MEMORANDUM

REVIEW TYPE: Site Plan Review
APPLYING FOR: Approval of 200 multifamily condominium units on one lot, including 30 MPDUs
PROJECT NAME: Fairfield at Germantown
CASE #: 8-03003A (Amendment)
REVIEW BASIS: §59-D-3 referencing §59-C-10.2.2

ZONE: RMX-2/R-200
LOCATION: Waters Road, 50 feet south of Wisteria Drive
MASTER PLAN: Germantown
APPLICANT: Centex Homes
FILING DATE: November 30, 2004
HEARING DATE: March 17, 2003

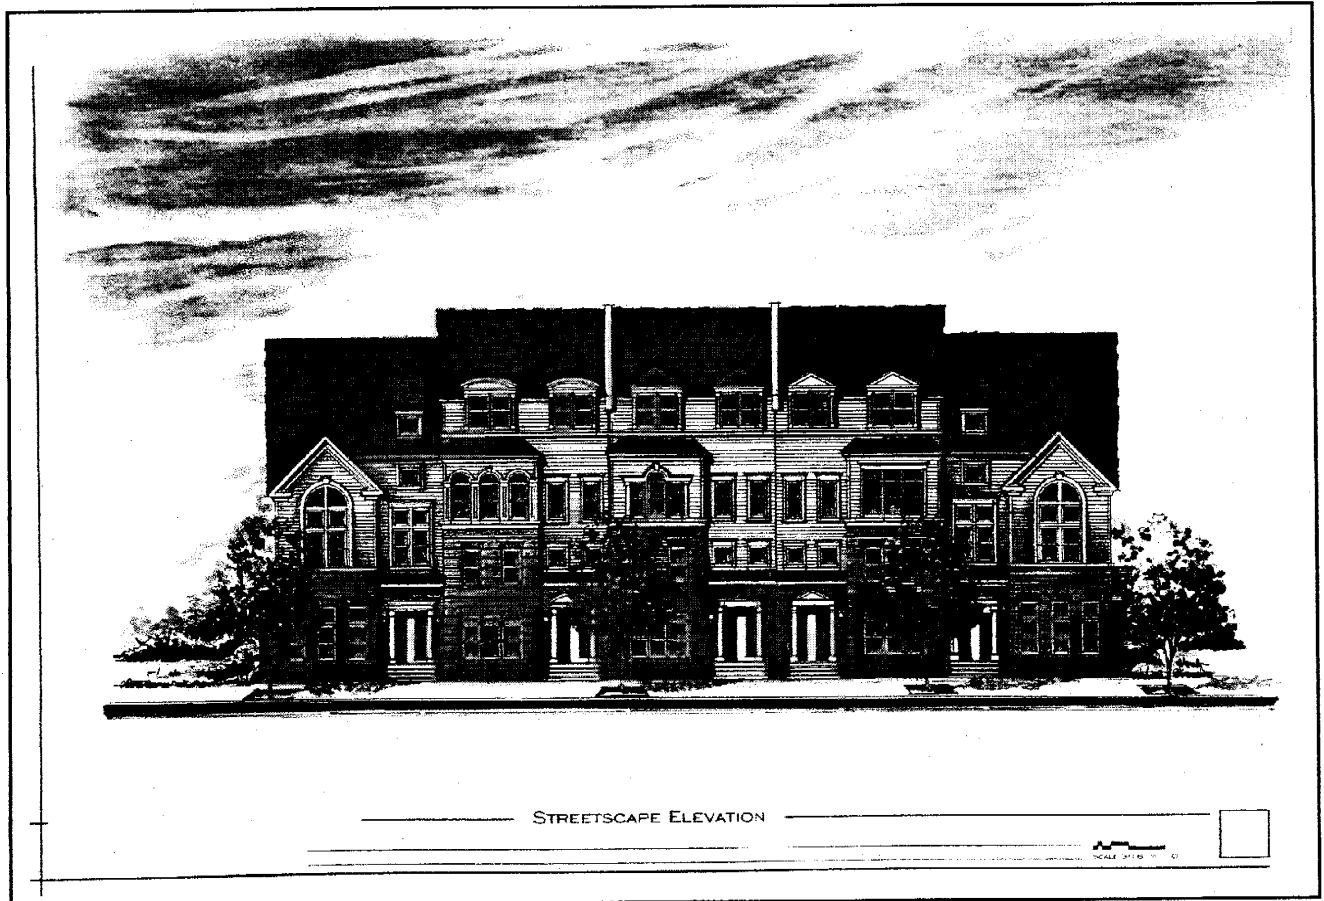
The proposed Amendment of the *Fairfield at Germantown Site Plan* addresses changes to Phase II of the residential portion of the mixed-use development. The proposed plan maintains the approved number of residential dwelling units and Moderately Priced Dwelling Units, the approved lot pattern, and recreational amenities while changing the unit type from multi-family rental apartments to multi-family condominium units.

Proposal: The proposed amendment will alter the approved site plan that features seven multi-family apartment buildings, substituting a plan comprised of 18 multi-family buildings constructed as "two-over-two" condominium units. The change is prompted by the applicant's study of market conditions and the desire to provide a new housing product to complement the surrounding housing supply of multi-family apartments and townhouses. It should be noted that all of the 30 required MPDUs will be provided as 3-bedroom units.

The amended plan features 200 residential units, sited in a geometric arrangement that, while more formal than the previous plan, maintains a corresponding relationship to the Phase I multifamily buildings to the north through street connections, pedestrian pattern, and location of the site's amenities. Recreational

Site Plan showing Housing and Commercial Phases

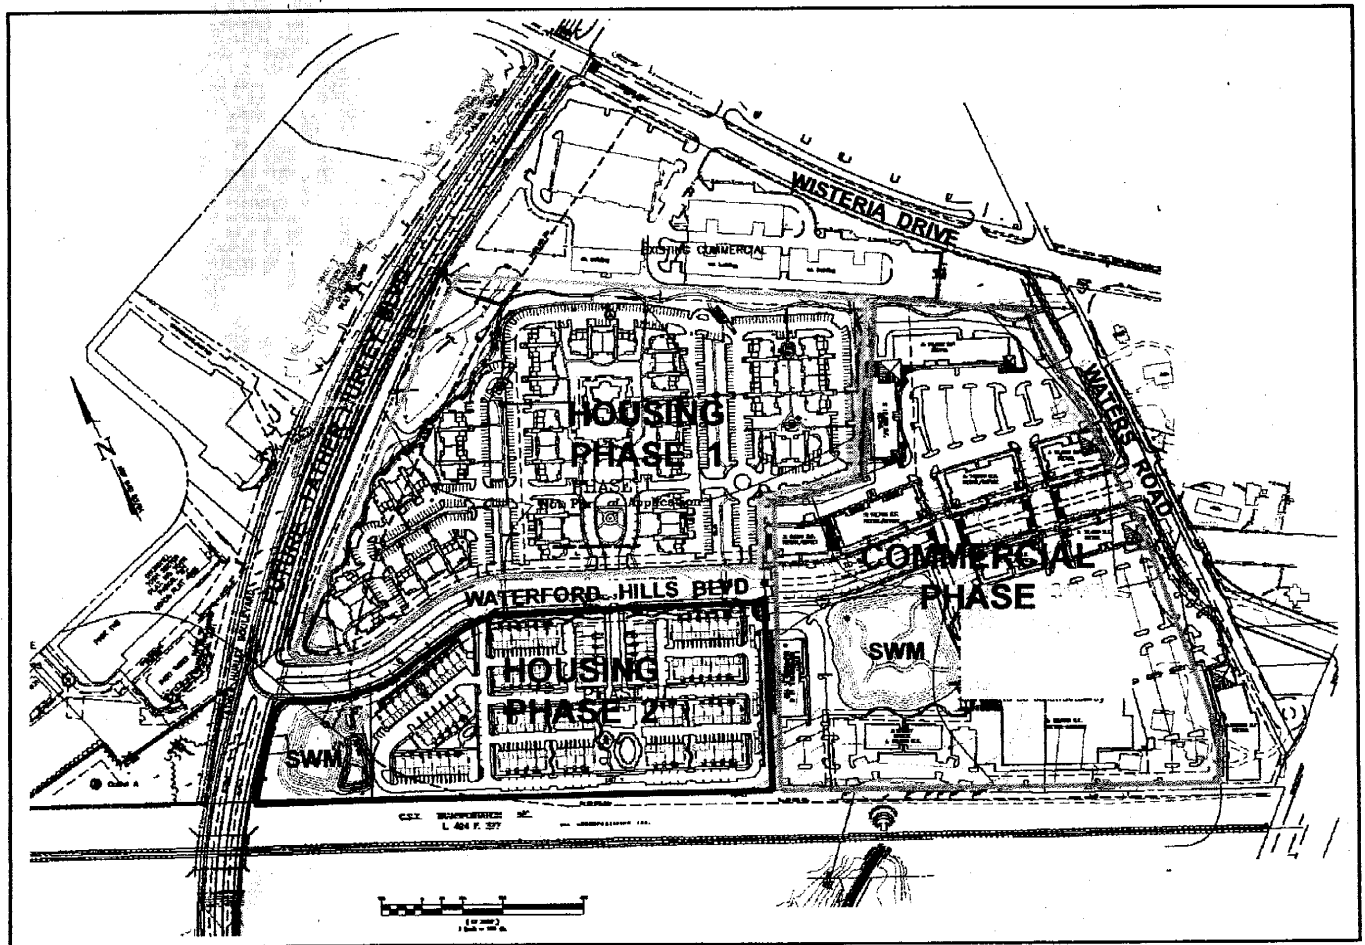
The subject application addresses the amendment of Phase II of the housing portion of the mixed-use project. Phase I will remain as approved for multi-family rental apartments. The subject site plan proposes 200 condominium units designed as “two-over-two” units.

The amendment of the Phase 2 portion of the housing within this RMX parcel proposes to maintain the number of housing units previously approved. The substitution of building type creates a number of challenges to the complementary balance previously depicted for this site. Whereas the previous approval provided essential "matching" developments straddling Waterford Hills Boulevard, the new proposal features a new building type that carries a scale and massing that more closely resembles attached housing. The articulation of the "two-over-two" buildings, that is, the "stacking" of units allowing two dwelling units per footprint provides an cumulative effect of greater density, primarily read through the proportion of height to footprint.
